**Addendum No.2
To Plans, Contract Documents and Specifications
IFB 14-024/KJS, Electrical Vault Replacement**

JACK BROOKS REGIONAL AIRPORT
 JEFFERSON COUNTY, TX
 ELECTRICAL VAULT REPLACEMENT
 PACKAGE 1

Jack Brooks Regional Airport – Electrical Vault Replacement Pre-Bid Meeting

To: Potential Bidders
From: Thomas D Dodson, PE
RE: Jack Brooks Regional Airport – Electrical Vault Replacement Project
Bidder Questions
Date: July 10, 2014

5 COPING JOINT / DBL LOCK STANDING SEAM
 SCALE N.T.S.

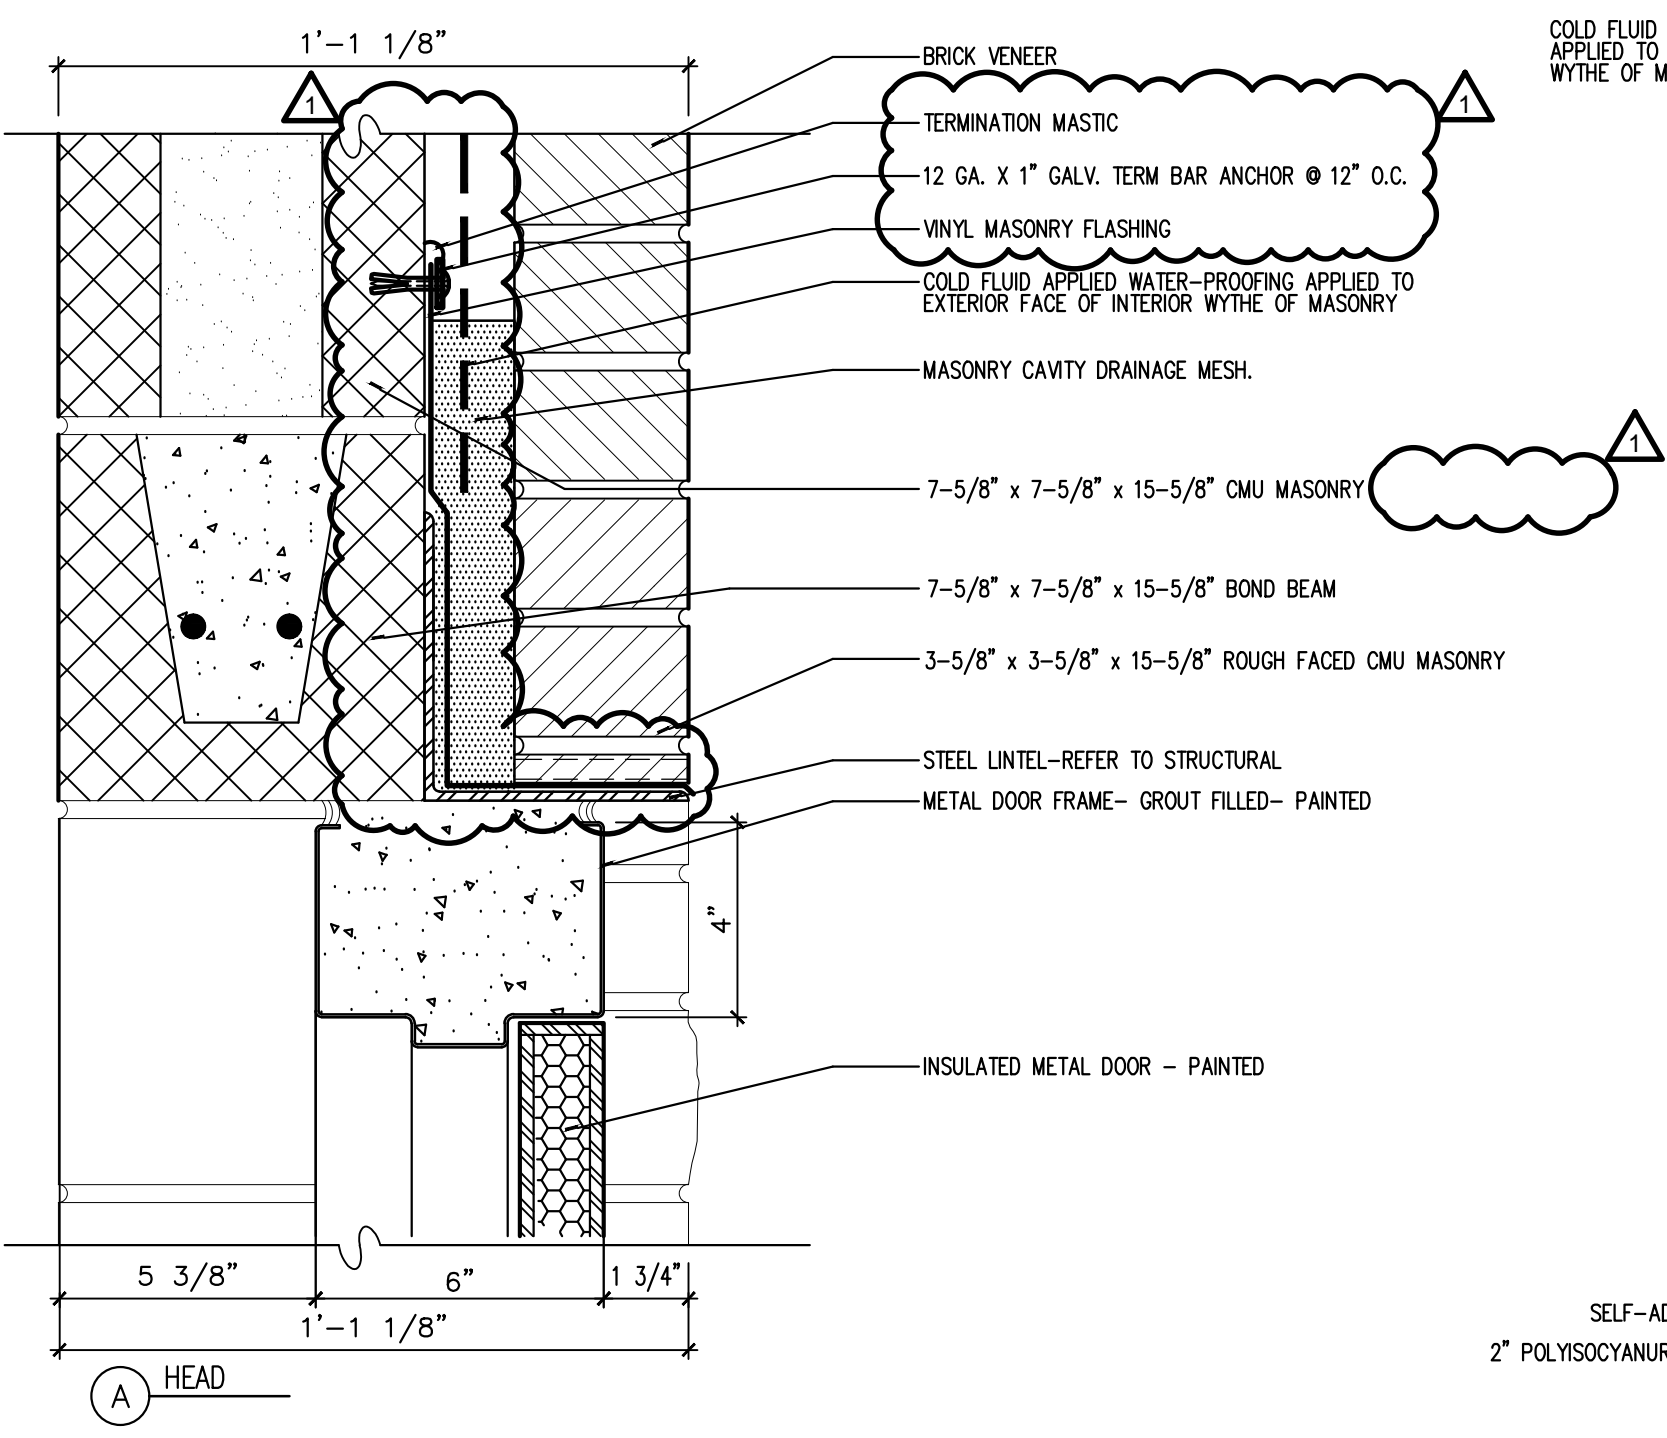
Question 5: In the building wall sections in the plans – what is the intent for fill in the CMU block?

Answer 5: On plan sheet A-101 Delete all references to perlite filled masonry. Load bearing CMU in this project shall be grout filled as directed on the structural drawings. See revised Sheet A-102 included in this addendum.
